Subject: Request for Additional Information for Review of Quad Cities Replacement Steam Dryer

**Quad Cities Units 1 and 2,
Individual RAI Responses for the Dryer Replacement Project**

Revision 5

May 3, 2005

Estimation of steam velocities in QC at EPU Conditions

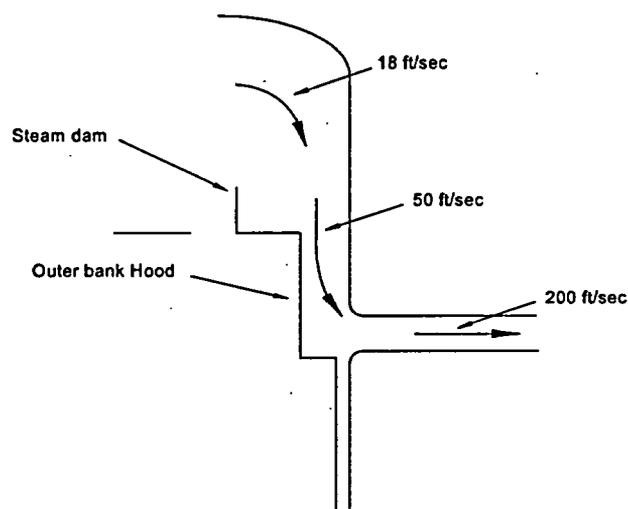
RAI #1 (a)

- (a) the basis for its assumption that acoustic loading as predicted by the acoustic circuit analysis is the principal load applied to the steam dryer,

Following completion of the extended power uprates (EPU), the steam dryers at Quad Cities, Units 1 (QC1) and 2 (QC2), experienced structural damage during subsequent operation. Finite element analysis (FEA) performed by General Electric (GE) indicated that the most heavily loaded areas of the steam dryer were the outer bank hoods opposite the main steam line (MSL) inlets. The FEA determined that a differential pressure of 1 to 4 pounds per square inch differential (psid) was needed to create the damage observed on the steam dryers

The sketch above estimates the mean steam velocities over the steam dam (dryer outlet), at the dryer outer bank hood in front of the MSL entrances, and in the MSL at EPU conditions. These velocities are 18 feet per second (ft/sec), 50 ft/sec, and 200 ft/sec, respectively. Given that strong turbulence has velocity fluctuations on the order of 10% of the mean velocity, pressure fluctuations p' resulting from shed eddies or turbulence are determined as follows:

The fluctuating pressures due to eddy shedding or turbulence on the outer bank hood cannot account for the damage observed, even if these fluctuations were increased five-fold.

New Dryer QC2 In-plant Peak Load at EPU Scaled Flow

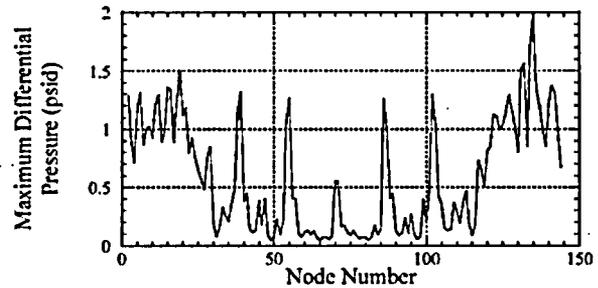
RAI # 2(e)

- (e) comparison of SMT test data to acoustic circuit analytical results and CFD predictions, and resolution of differences (including maximum pressure points and locations); and

Exelon has used both QC1 SMT results and QC2 in-plant loads with acoustic circuit modeling to develop the two new dryer load cases. CFD analysis was not used for load definition. For the two design load cases that are used for the new dryer analyses, there are differences in the frequency and amplitudes of the responses as shown below. There are a number of known reasons for the differences. First, inputs used to develop the load cases are from two different plants. Second, the new steam dryer was analytically inserted into the Helmholtz solver and the direct measurement for the SMT, as opposed to using instrument lines and direct measurement with a strain gauge for the in-plant data. To be sure that the new dryer design is structurally viable, the design analyses used both load cases. In addition, both load cases included plus 10% and minus 10% frequency shifts, giving six finite element evaluations.

Figure 1

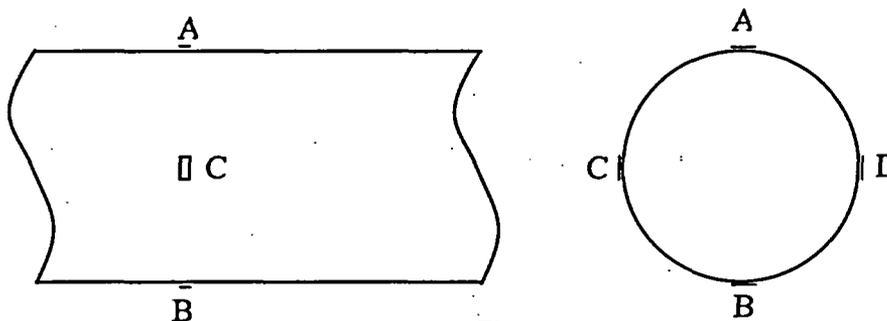
RAI #3(e)

- (e) validation of the capability and sensitivity of the MSL strain gauges and their setup for inferring changes in internal pressures in the MSLs;

Two sets of strain gauges composed of two strain gauges each will be installed 180 degrees apart in the circumferential direction (Figure 1) and configured in opposite arms of the Wheatstone bridge. Four strain gauges would be installed around the circumference of the pipe, oriented in the hoop direction. Each strain gauge should be set approximately 90° apart. One set (channel) of strain gauges will consist of strain gauges A and B and the other set (channel) will consist of strain gauges C and D. Each set, a separate channel, will provide approximately the same strain time history with the radial motion in phase, time, and frequency. The ovaling mode, when compared between the two channels, will be out of phase (180 degrees). This distinction can be analyzed during the data reduction phase of the testing by using two channel analysis and evaluating the cross spectrum in magnitude and phase, or by bandpass filtering around suspected ovaling mode frequencies. In addition, by adding the two channels, the ovaling mode should cancel and the radial motion should add (double) in amplitude.

The strain gauge is capacitive discharge welded to the pipe; consequently, it is theoretically sensitive to infinitesimally small strain. The QC2 data acquisition system (DAS) includes a 24-bit analog to digital (A/D) converter coupled with a strain gauge signal conditioner that produces a strain sensitivity of 0.01 Volts per micro-strain ($V/\mu\epsilon$). This combination provides a strain resolution of $0.000012\mu\epsilon$ on a ± 1 Volt input range. Strain gauge circuitry will be calibrated using a shunt calibration technique commonly used with the Wheatstone bridge. Measurement system uncertainty has been determined to be $\pm 3.03\%$. The conversion from strain to internal pressure requires implementation of hoop equations to relate the measured strain to internal pipe pressure. The application of these equations provides a relationship between strain and pressure of $3.98\text{psi}/\mu\epsilon$ with an overall uncertainty of 6.3%, which includes the uncertainty in the pipe characteristics and measurement system.

Figure 1: Replacement Steam Dryer

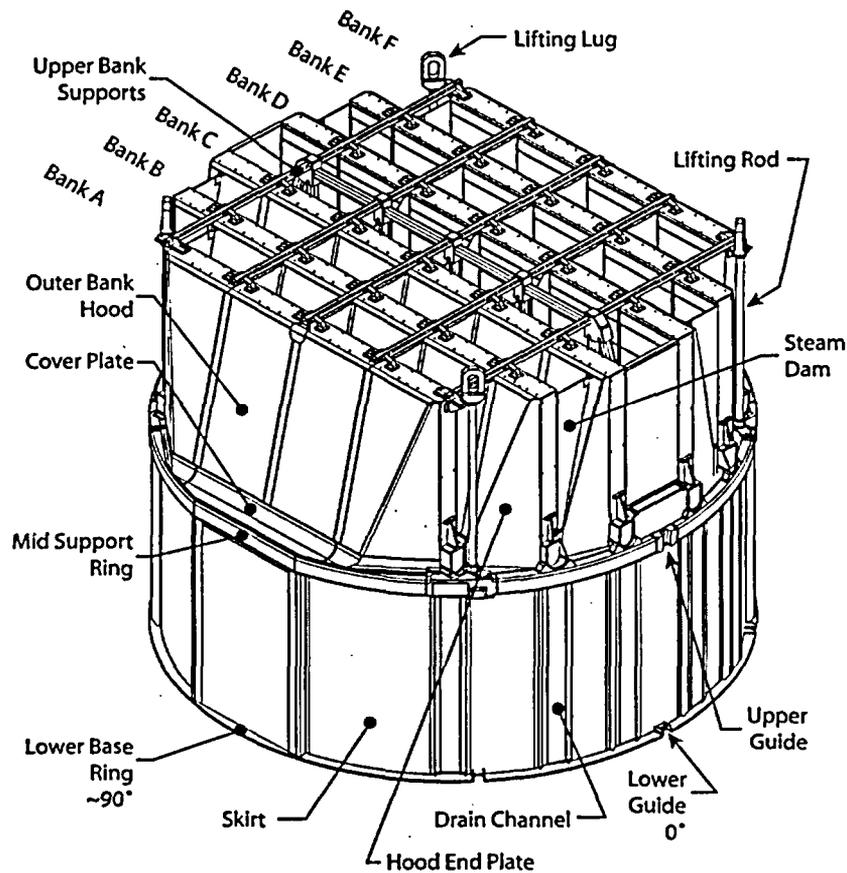
The licensee is requested to provide the following information regarding the replacement steam dryers for Quad Cities Units 1 and 2:

Table 1: Comparison of Major Steam Dryer Configuration Parameters

New Dryer QC2 In-plant Peak Load at EPU Scaled Flow

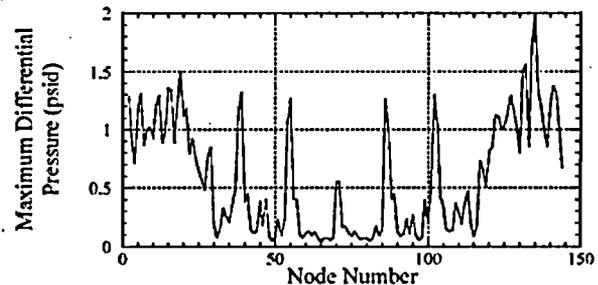
RAI # 5(c)

- (c) comparison of the CFD and acoustic circuit analysis loads on the steam dryer;

CFD analysis was not used to define loads on the QC replacement steam dryers. Rather, Exelon developed two separate dryer load cases using data collected from two independent sources. One source of data was the 1/17th sub-scale model testing of the QC1 reactor vessel and main steam piping. The second source of data was instrumentation installed on the QC2 reactor vessel and main steam piping during a plant startup.

The frequency and amplitudes of the response for the two design load cases are shown below. There are a number of known reasons for the differences. First, inputs used to develop the load cases are from two different reactor vessels and main steam piping configurations. Second, the new steam dryer was analytically inserted into the Helmholtz solver and the direct measurement for the SMT, as opposed to using instrument lines and direct measurement with a strain gauge for the in-plant data.

To ensure that the new dryer design was structurally viable, the design analysis used both load cases. In addition, both load cases included plus 10% and minus 10% frequency shifts, giving six finite element evaluations. The new dryer was then designed using the maximum stress intensity factors from all of the six finite element evaluations performed.

QC2 May 2005 PLANNED OUTAGE STARTUP POWER ASCENSION

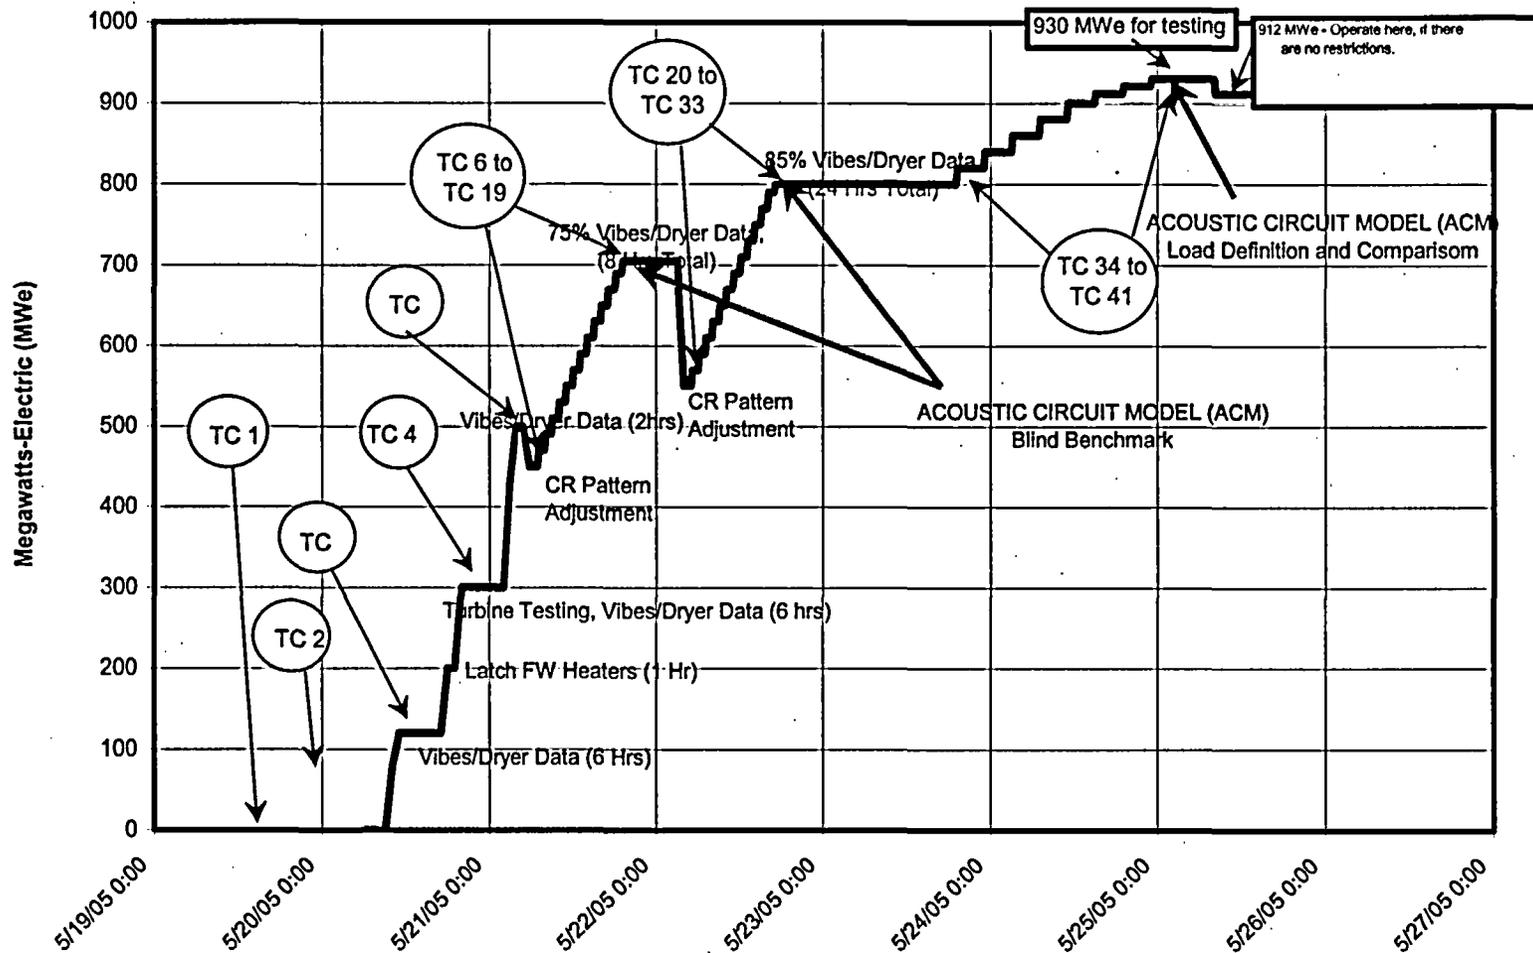
The licensee is requested to describe a startup plan that will provide confidence in the integrity of the Quad Cities replacement steam dryers during startup and operation at EPU conditions. The plan is expected to include hold points during power ascension, data and parameters to be measured, acceptance criteria that will initiate proactive measures to address inadequate steam dryer performance prior to failure (e.g., evaluation of plant and dryer data, potential loose parts effects, and dryer inspection results), and decision criteria for allowing continued plant operation or commencing plant shutdown. For example, the plan is expected to provide for the performance of blind predictions of the loading of the Quad Cities replacement steam dryer by the acoustic circuit model based on MSL strain gauge data at pre-EPU baseline conditions and at specific hold points as part of the power ascension to EPU operation.

A copy of the power ascension map is provided below. Reactor power will be raised to the pre-EPU power level of 2511 megawatts thermal (MWt) over a 3.5-day period. Data will be taken at 33 test conditions (TCs) up to 2511 MWt. A hold period of approximately 24 hours is planned at TC 33 while:
